## Memorandum

Subject: Clarification of Order 8260.3B, United States Standard for Terminal Instrument Procedures (TERPS), Paragraph 1750d

AVN-100 CRITERIA COORDINATION COMMITTEE  
HISTORY RECORD  
Issue# 06-CCC-011

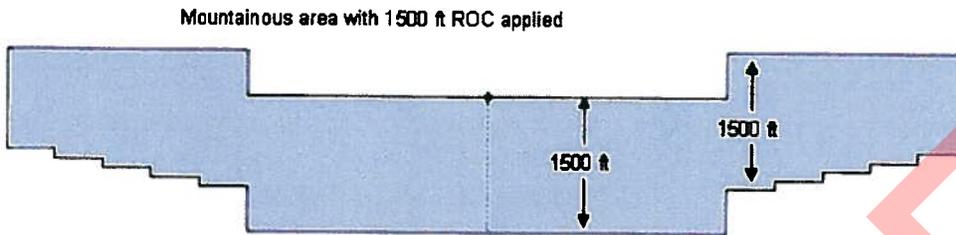
Paragraph 1750d.(2)(c) is sufficient for the above application where 2000 ft of ROC is applied to the primary area over mountainous terrain. However, it's inadequate when ROC has been reduced to 1700 ft or 1500 ft since the requirement as written would still require adding a full 1000 ft to the basic secondary clearance. The following figure illustrates this problem when 1500 ft of ROC has been applied in the primary area.

Without any provision to reduce the addition of 1000 ft in the secondary area, the resultant MOCA could be as much as 500 ft greater than required. On the other hand, the criteria for VOR airways do contain provisions to reduce secondary ROC over mountainous terrain when the primary ROC has been reduced to less than 2000 ft:

**Conclusion.** The intent of the current criteria is to apply an additional 1000 ft of secondary obstacle clearance only when the primary obstacle clearance is 2000 ft.

When primary obstacle clearance in mountainous areas has been reduced to 1700 ft, add 700 ft to the values specified in paragraphs 1750.d.(2) (a) and (b). When primary obstacle clearance in mountainous areas has been reduced to 1500 ft, add 500 ft to the values specified in paragraphs 1750.d.(2) (a) and (b).
